# Chapter 25 Small Wastewater Systems Revisions

Wyoming Department of Environmental Quality  
Water Quality Division  
Principal Regulation Engineer  
Frank A Strong IV, P.E.

## Section 12 – Pressure Distribution Systems

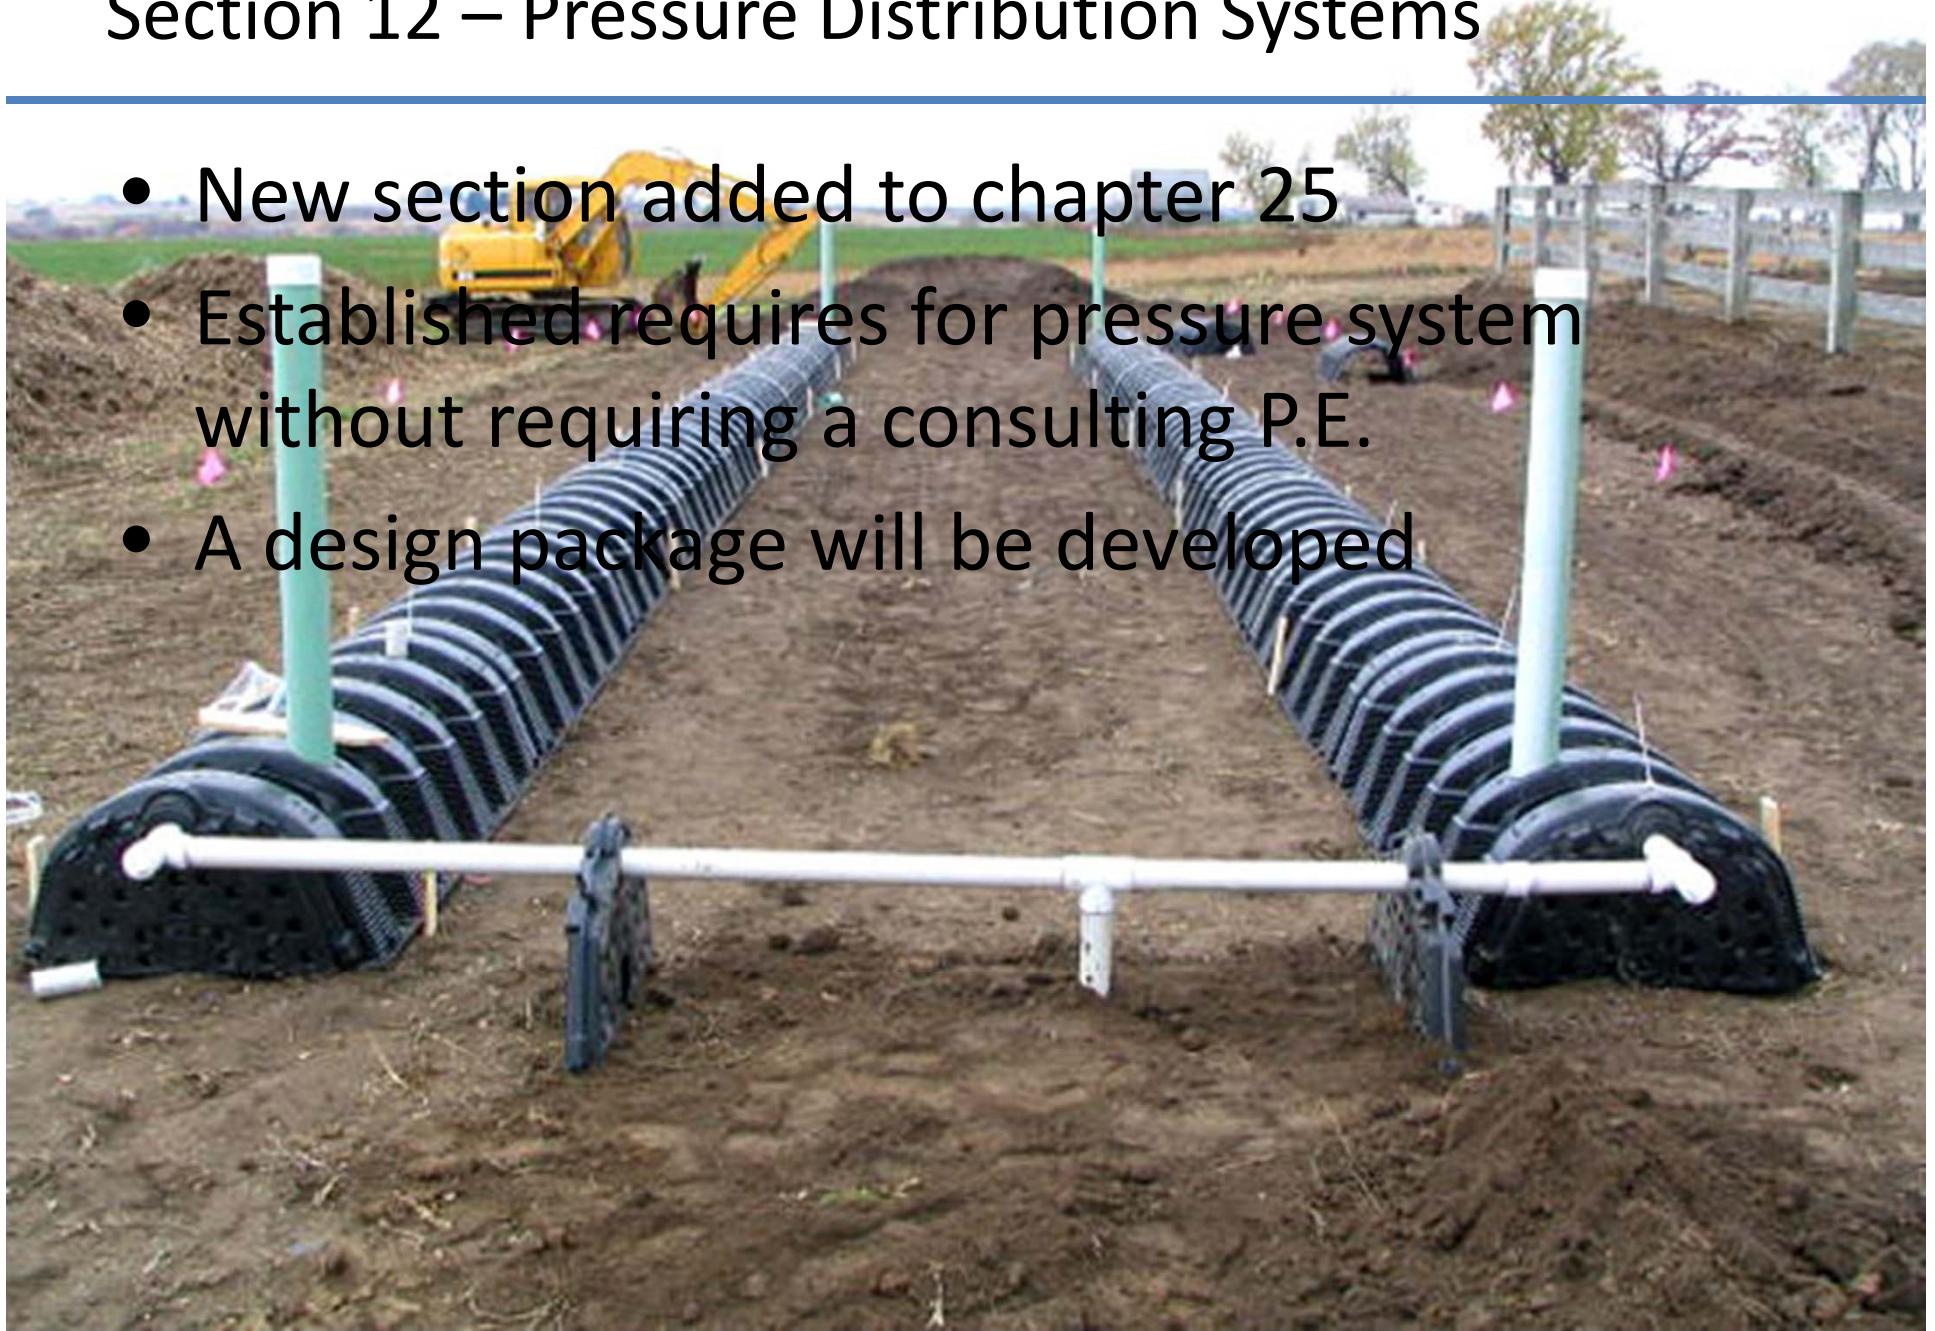
- New section added to chapter 25
- Established requires for pressure system without requiring a consulting P.E.
- A design package will be developed
